AMATEUR SERVICE AGENCY BULLETIN NO. 1016

EQUIPMENT TYPE: KWM-2/2A TRANSCEIVER

- SUBJECT: A. CRYSTAL CALIBRATION
 B. "YELP" PROBLEM
 C. REDUCE LOW-FREQUENCY SPURIOUS
 D. HIGH-FREQUENCY TWEETS
 E. ELIMINATE 0.455-KC SIGNAL BYPASSING TRANSMIT MIXER
 F. IMPROVE CARRIER BALANCE

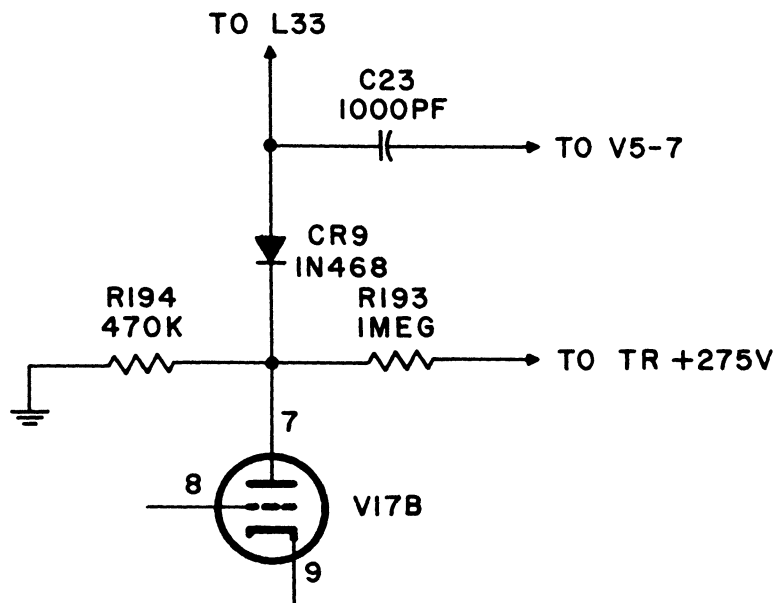
E. Eliminate 455-KC Signal Bypassing Transmit Mixer

In some units, a "sneak" circuit has allowed a portion of the 455-kc signal to bypass the first transmit mixer. This can be eliminated by performing the following changes:

1. Replace the 220K resistor R193 with a megohm, 1/4-watt resistor (745-0857-000).
2. Replace the 0.1-megohm resistor R194 with a 470K, 1/2-watt resistor (745-1464-000).
3. Relocate the 1N458 diode, CR9, to the position shown below:

F. Improve Carrier Balance

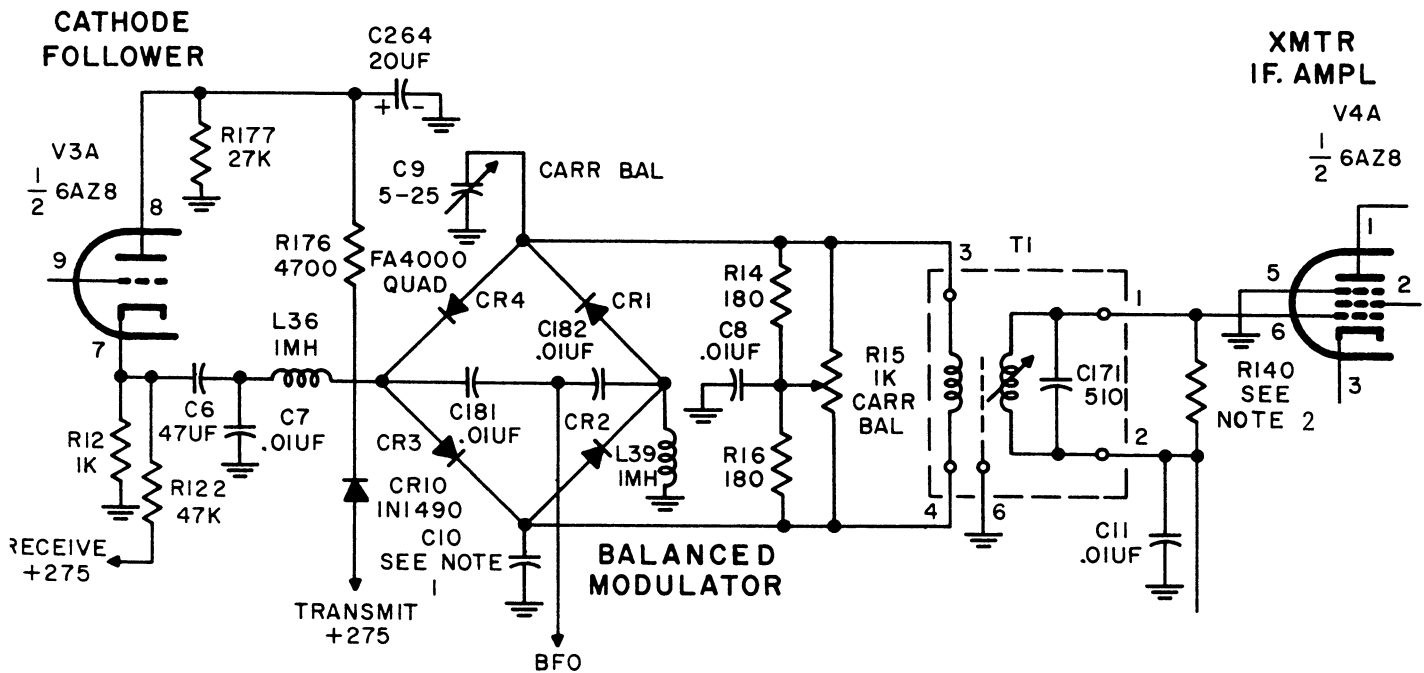
A number of changes have been made in the balanced modulator circuitry to improve the carrier balance. The current production version is shown below:

- NOTES:
1. Capacitor, C10, value varies from 20-pf to 150-pf.
 2. Resistor, R140, selected in production, value varies from 560-ohms to 1.2K.
 3. Capacitor, C171, is a part of T1.
